TECHNICAL STAFF REPORT

Case No./Petitioner: GPA 2018-01/Council Chairperson at the Request of Erickson Living Properties II, LLC

Request: AN ACT amending the General Plan for Howard County (PlanHoward 2030) to adjust the Planned Service Area for water and sewer service to include approximately 61 acres, located west of Clarksville Pike (Md Route 108) and south of Sheppard Lane, in Clarksville, Howard County, Maryland; to adjust the Growth Tier Maps and incorporate the property within Growth Tier 1; and further designate the property as a Targeted Growth and Revitalization Designated Place Type; and provide that certain adjustments will be null and void unless certain conditions are met; and generally relating to PlanHoward 2030.

Figure 1: Amended Map 4-1 Rural Land Preservation Planned Service Area Boundary (PSA) and Priority Funding Area Boundary (PFA).

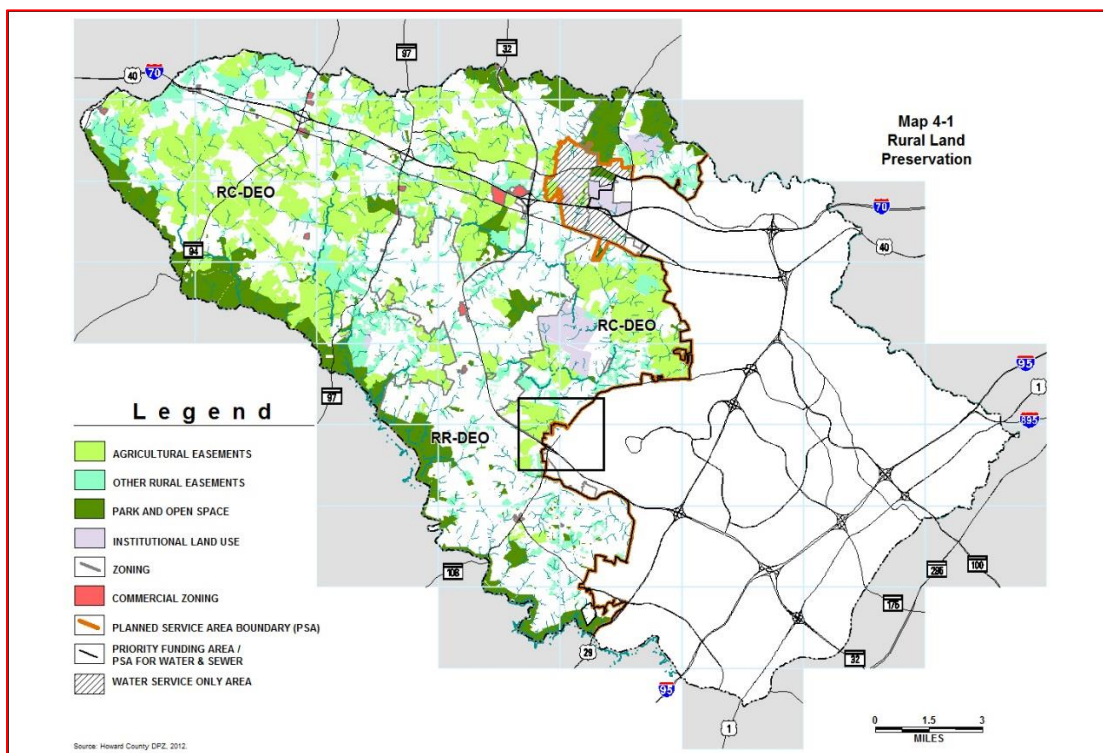
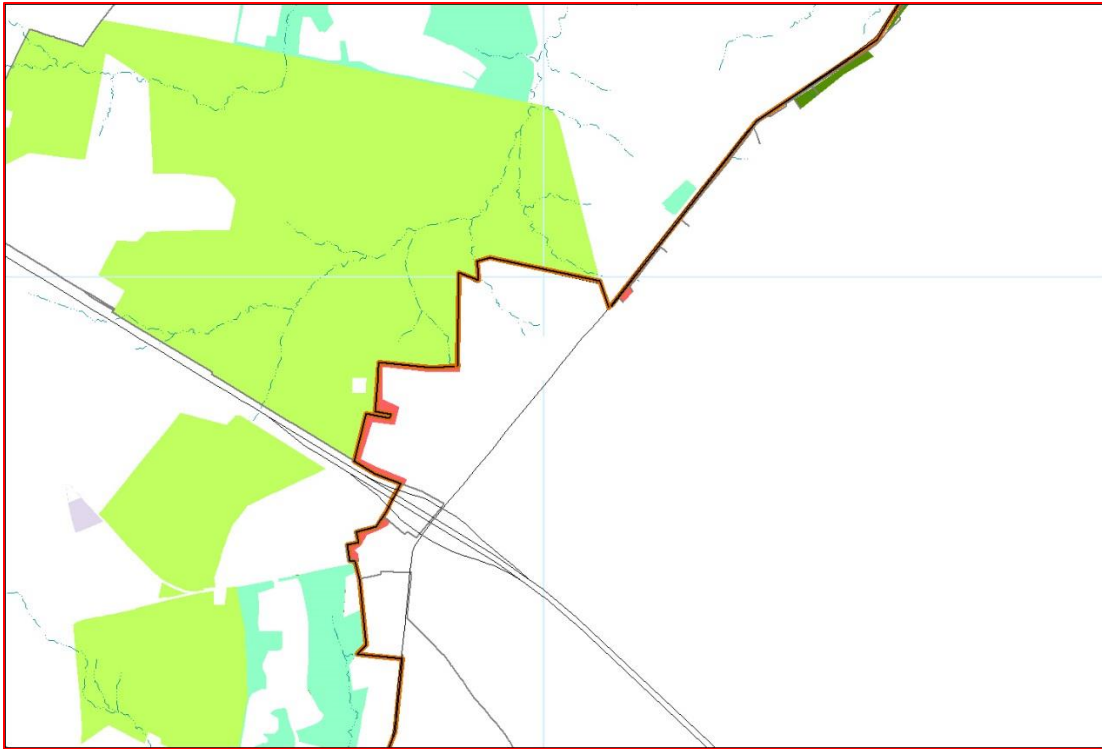
While the Property is currently not preserved under state or county preservation programs, it does adjoin land encumbered by agricultural easements to the west and north and residential development farther north. The Property is also adjacent to and includes land within the PSA to the east and south. This limits possible PSA expansions now and/or in the future. *PlanHoward 2030* adopted a similar minor PSA expansion in the Clarksville area for the Hoddinott property. Given the surrounding land uses and preserved land, the PSA is not likely to expand west, beyond the subject Property. (see Fig. 1 and 2).

Figure 5: Amended Map 6-2 Designated Place Types Planned Service Area Boundary (PSA) and Priority Funding Area Boundary (PFA).

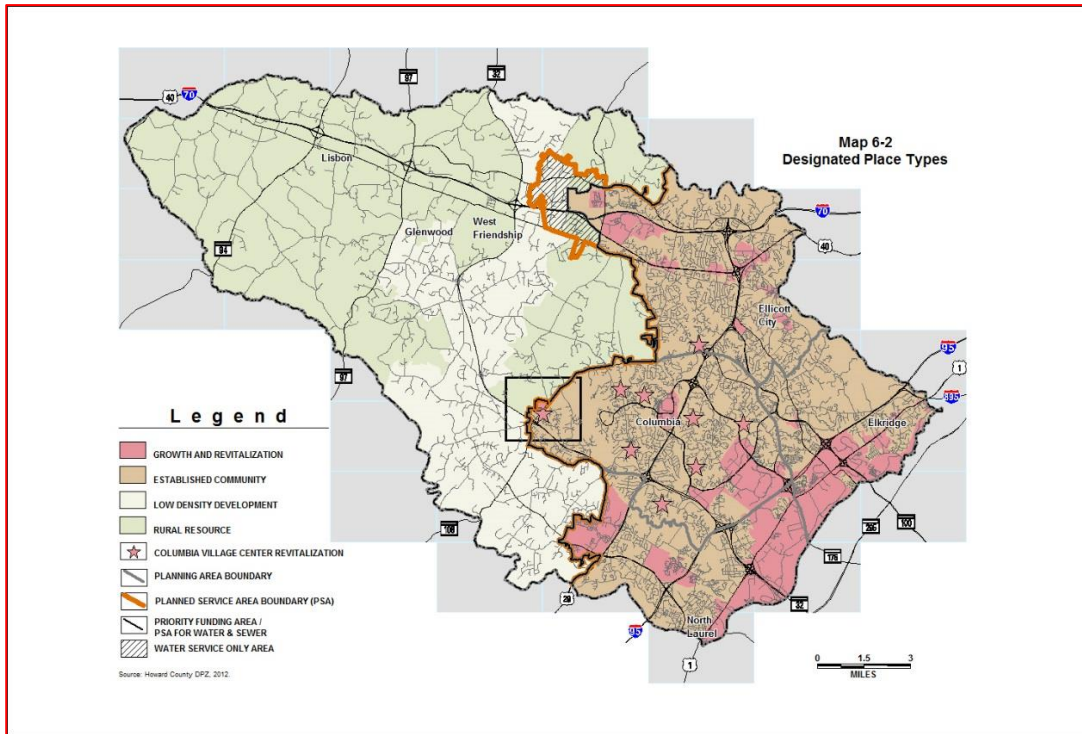
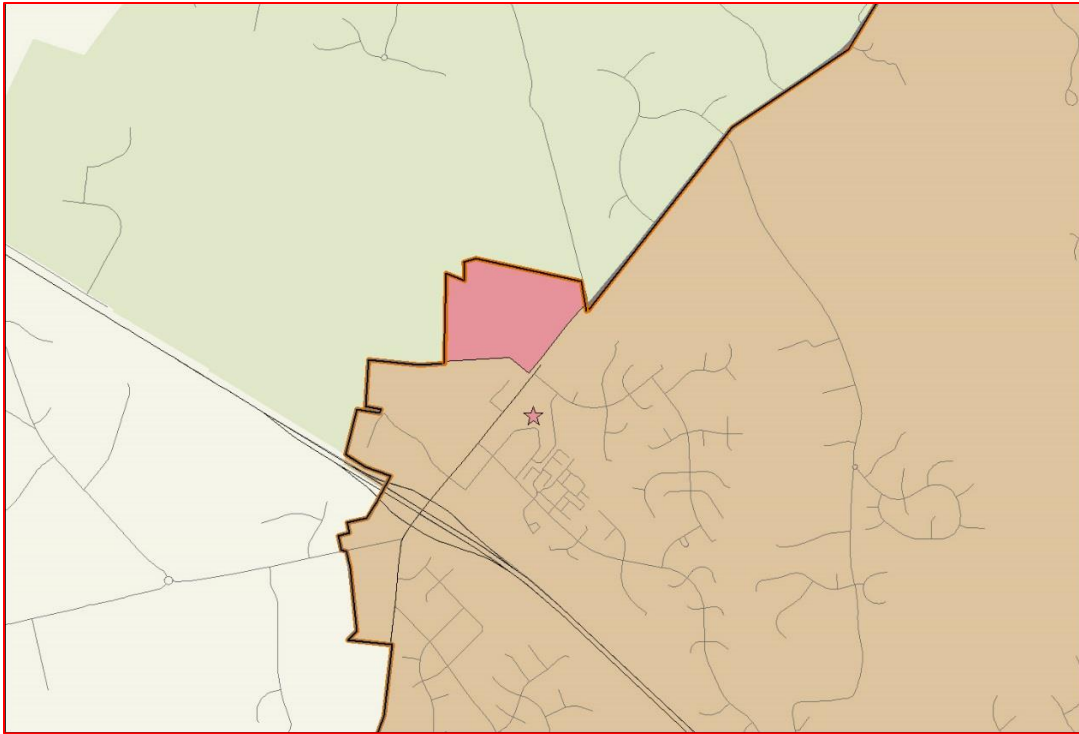
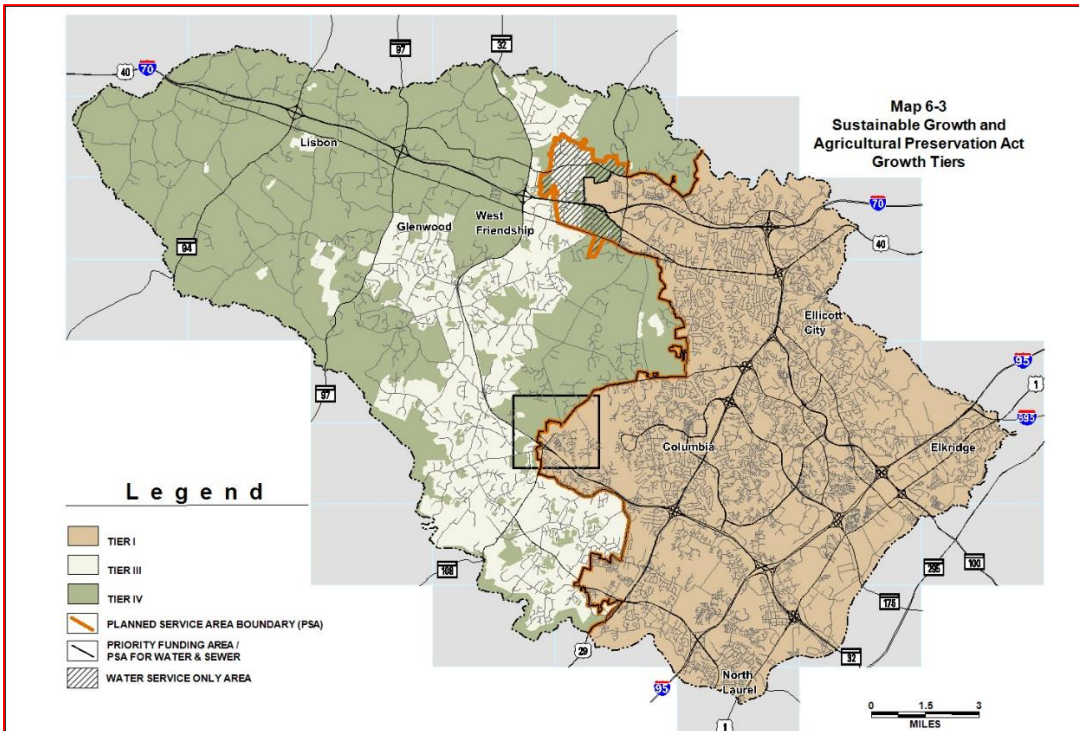
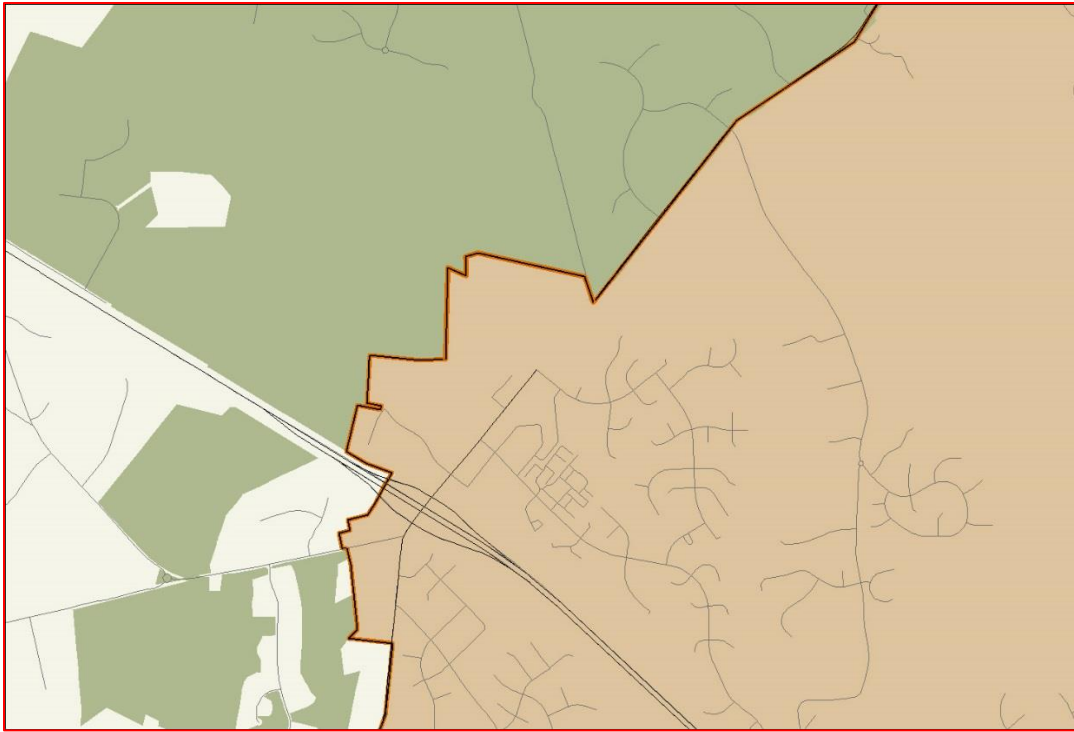
GPA 2018-01 proposes to change the Property’s Designated Place Type from Rural Resource to Growth and Revitalization (see Fig. 5 and 6) and include it in Growth Tier I (see Fig. 7 and 8). The growth tier amendment is proposed to allow consistency with those areas in the county that are served by public water and sewer. However, such a change should occur only if the PSA expansion is approved.

The amendment to change place types from Rural Resource to Growth and Revitalization is a significant shift for this area. Except for Maple Lawn and Turf Valley, areas in the county targeted for growth and revitalization have generally been in the east and on, or near, commercial corridors. While Route 108 borders Rural Resource land, it also abuts the PSA and is a commercial corridor. These characteristics could open the door to consider a change in the designated place type. Although an Established Community place type may be more appropriate, given the scale and character of the proposed development, the Growth and Revitalization designation provides the necessary housing allocations. As with any major change like this, the potential consequences should be weighed against the potential benefits of the CCRC to the County. These may include housing and continuing care for a rising senior population, transportation improvements, and community amenities, which will be assessed more thoroughly during the CEF rezoning process and site development review.

Figure 11: Development Concept Plan Supplement: Illustrative Site Plan.

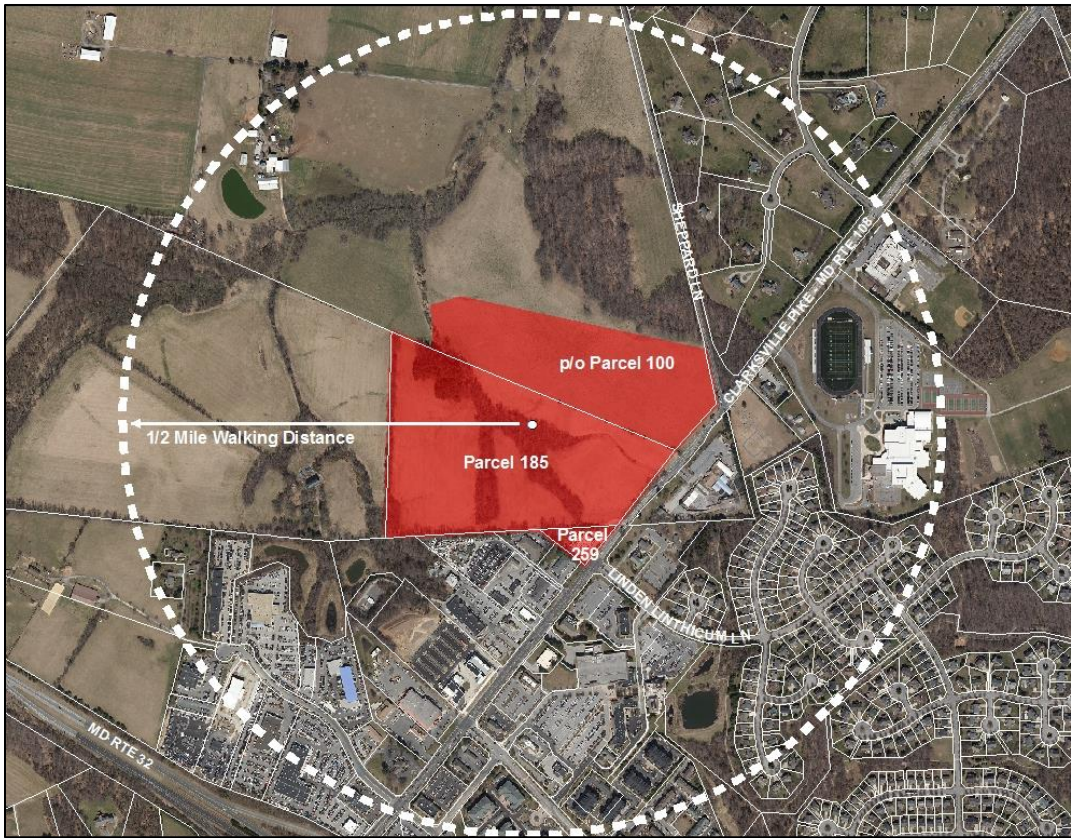
Figure 11 shows the DCP, which proposes one to three story buildings along the Sheppard Lane frontage. Building height increases up to four stories along Clarksville Pike as a transition between lower density residential/ agricultural uses and higher intensity commercial ones. Additionally, the existing gas station is shown as being redeveloped with enhanced landscaping and streetscape improvements that incorporate improved lighting and environmental controls and enhanced circulation and pedestrian safety features.
